C S Stokes and Associates Limited

18th March 2014

Premises: Grenfell Tower, Testerton, Barandon and Hurstway Walks on the Lancaster West Estate

Thank you for asking me to comment on the questions raised by the London Fire Brigade (LFB) officers during they visit to the above buildings on the Lancaster West estate on the 12th March. The LFB fire officers were Ben Lewis, Mathew Ramsey and Dan Hussey and you were accompanied by Mr Bruce Sounes of STUDIO E, the questions asked were contained in your e mails to me from notes that were taken during the visit. I visited the above premises yesterday, Monday the 17th March 2014 to gather the information for this report, the information on service dates etc was obtained from the contractors servicing and maintenance logbooks held on site and from records from the TMO's engineers section at the Hub.

Dry rising main

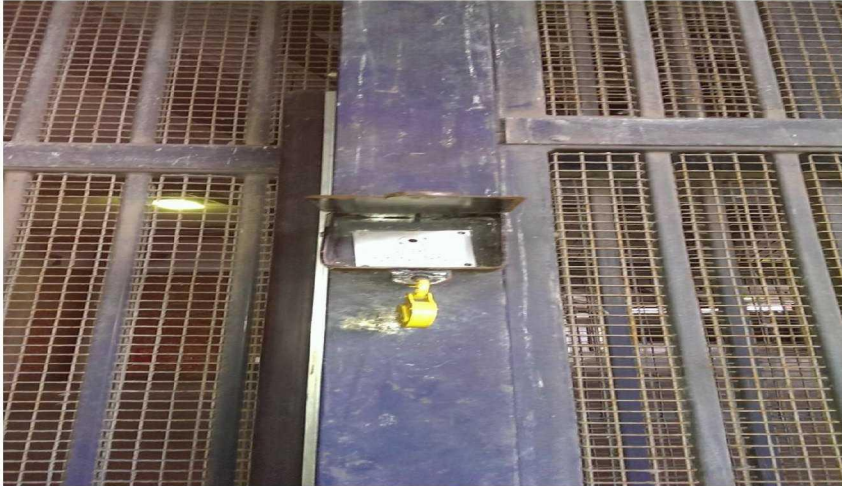
There are dry rising mains installed in these figure blocks, the inlet is located at the lower ground floor level, in the areas underneath the residential areas with the outlets being located directly above the inlets. Each riser is numbered with black paint on the front of the dry riser box, so number 6 dry riser inlet feeds number 6 dry riser outlet which is located directly above it. The dry risers in Testerton and Hurstway Walks were last tested by M and P Fire Protection Limited on the 30th December 2013 according to the contractors label fixed inside these inlet and outlet boxes. Please see the recommendation reference Barandon Walk. Located above the dry riser inlets there is another red painted box this contains an outlet from a ring main, this is different from a town main which is the normal way for water to be provided. As far as I am aware this ring main was installed when the premises was constructed, it could have been considered that a wall mounted water ring main would be easier to maintain than an under ground hydrant one. A ring main is a recognised way of providing water to inaccessible places it also has the advantage that the fire service do not need to use a standpipe key and bar etc when connecting to it. In this case this is a water filled pipe above ground rather than underground which is maintained serviceable by the TMO, the last test was undertaken by M and P Fire Protection Limited on the 29th November 2013 according to the contractors label fixed inside the ring main boxes. The water pressure at the time of this last test was 4.4 bar.

How this system is used by the fire service is a matter for them to decided, also it is up to them to decide if they drive fire appliances into the lower ground floor level roads to apply pressure to the system so that they have a fire fight jet on the upper floor levels. There have been different padlocks fitted to the ring main boxes that the normal FB padlocks, the currently fitted padlocks should be removed and the standard FB padlocks fitted so that the LFB can open the boxes easily.

9. There have been different padlocks fitted to the ring main boxes that the normal FB padlocks, the currently fitted padlocks should be removed and the standard FB padlocks fitted to each ring main box so that the LFB can open the boxes easily.
